TTS REMOVAL PLAN

Project Name: Iowa DOT, Bettenforf I-74 Temporary Relocation - Grant St to Mississippi Bridge Pier
 Scale: NONE

OSP Log: 82180401
 Drawing: 2 of 5
 Size: 11 x 17

ITS PLAN

Pier 30 Gilbert St. – I-74 Ex. Riser with Pull Box

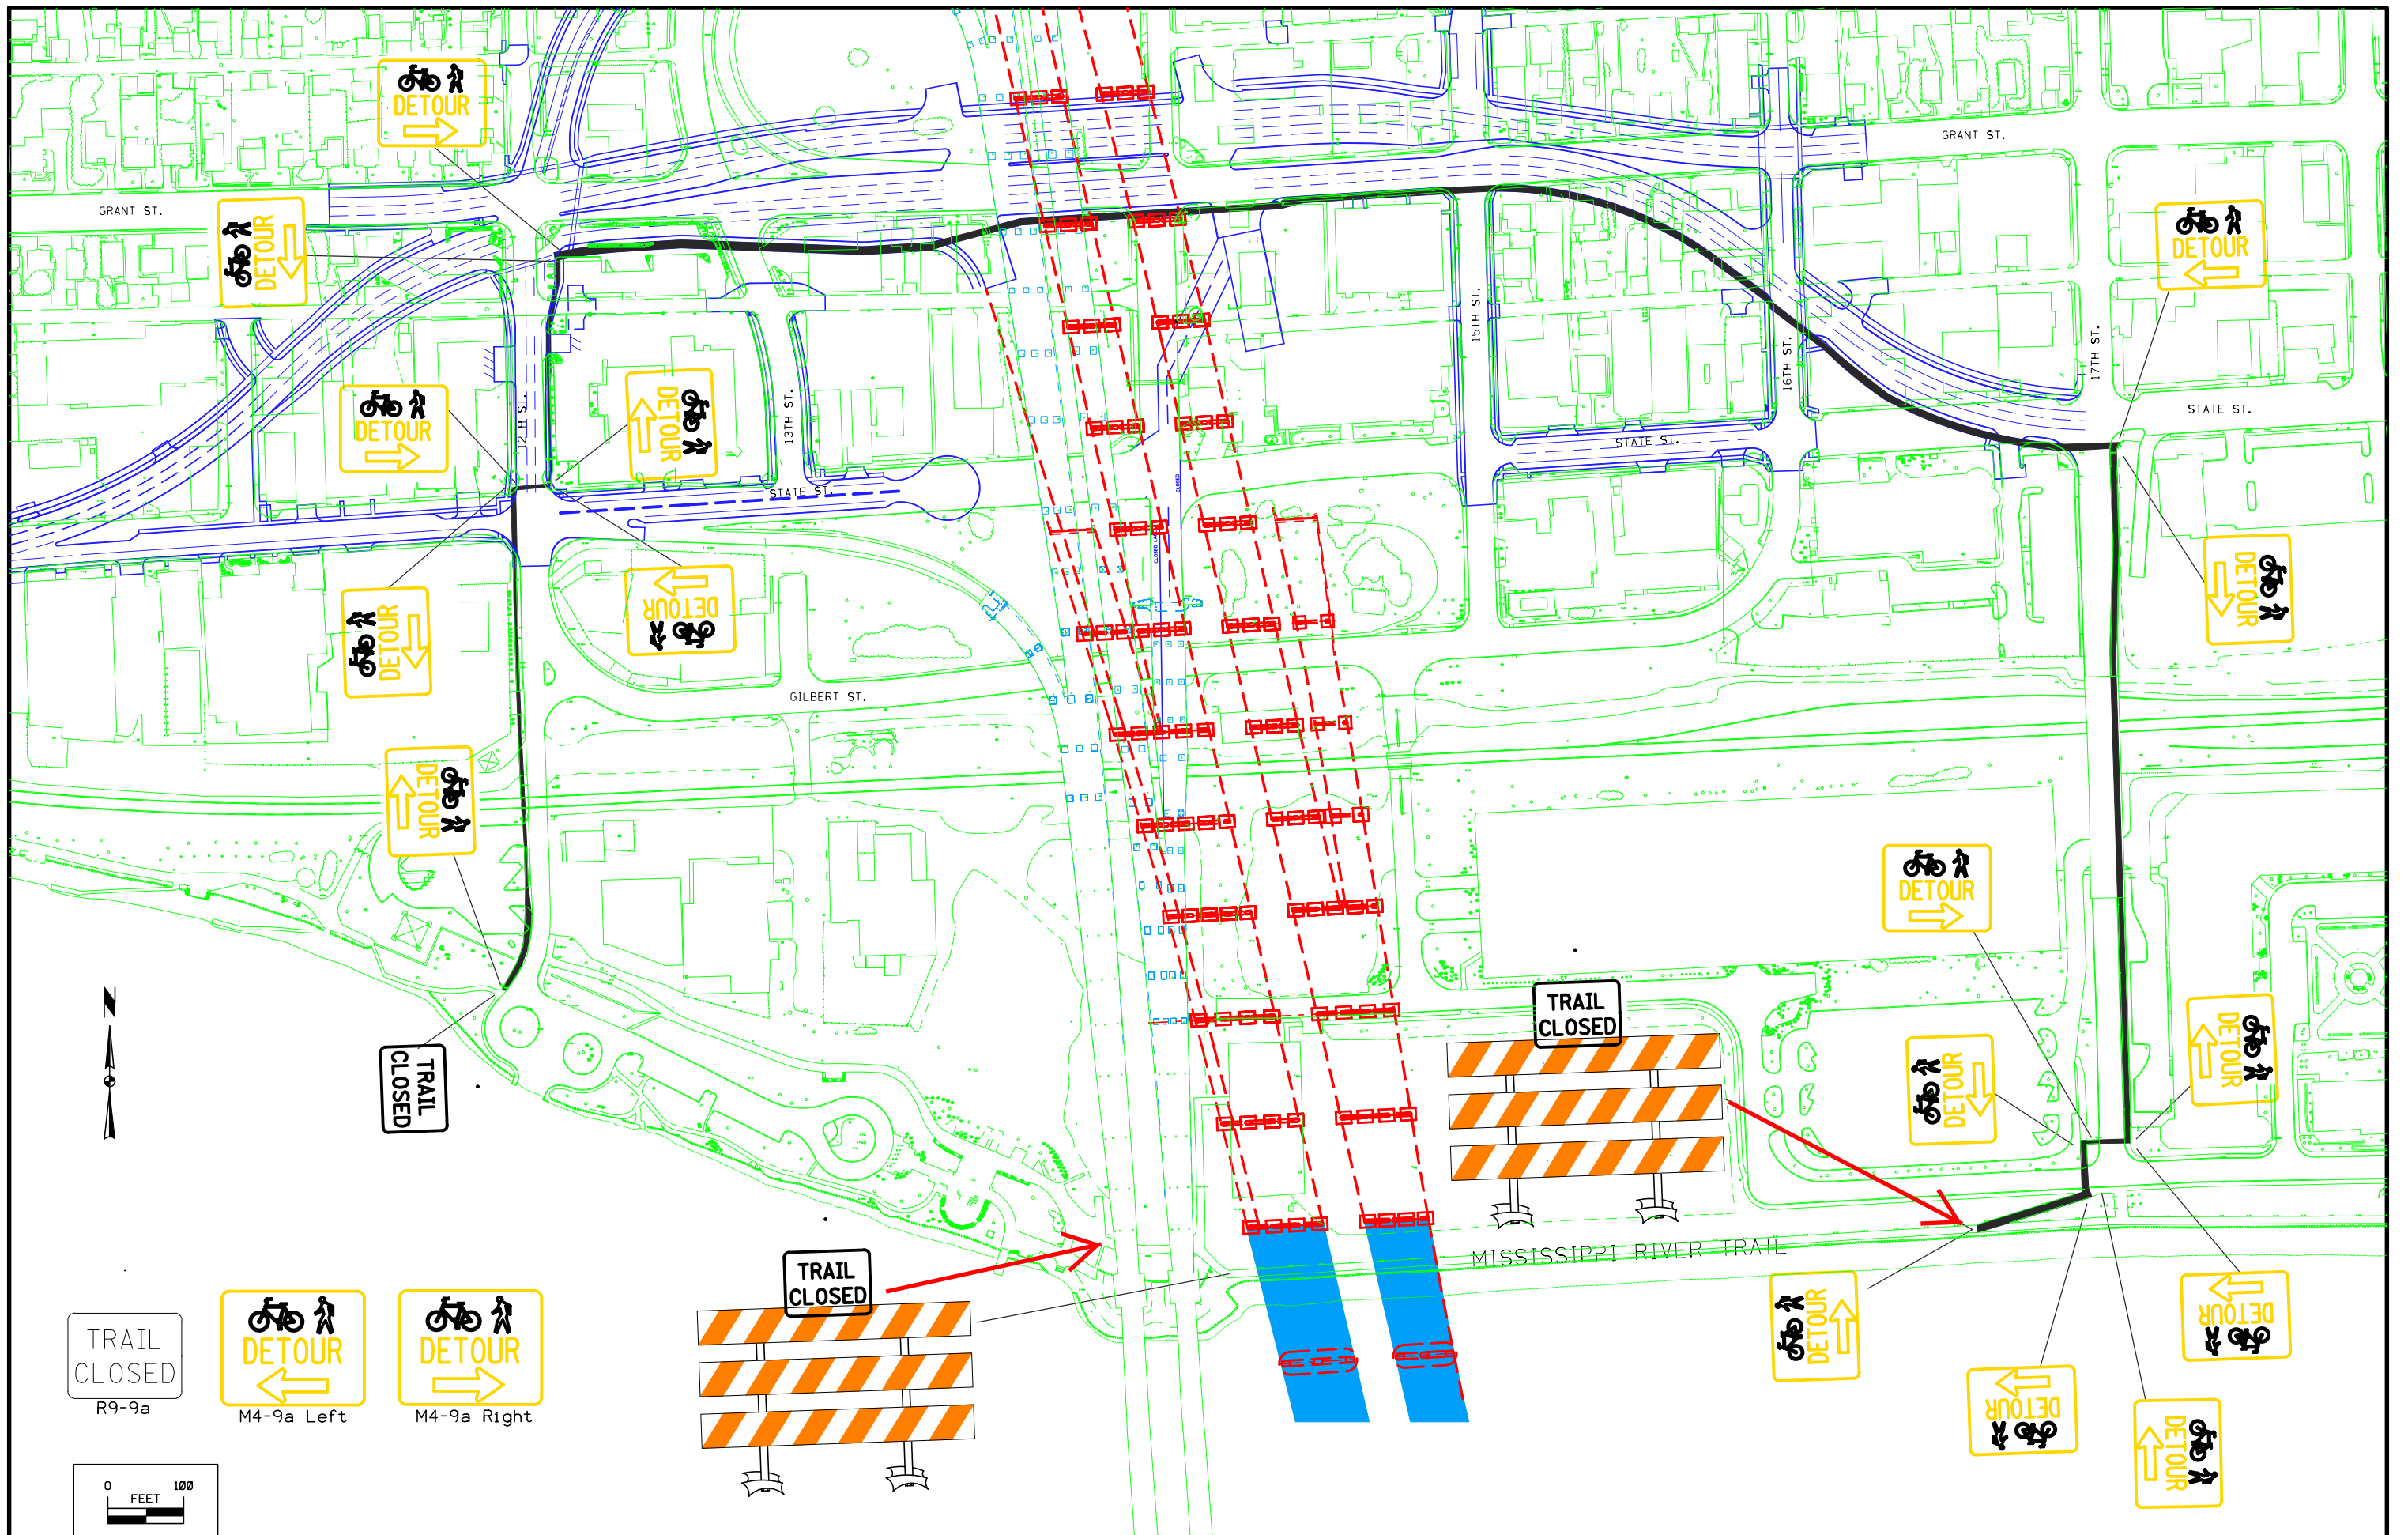
- Ex. Pull Box and Handhole.
- Verify 96f in pull box.
- This will be the location to cut the 96f and pull back to the south.
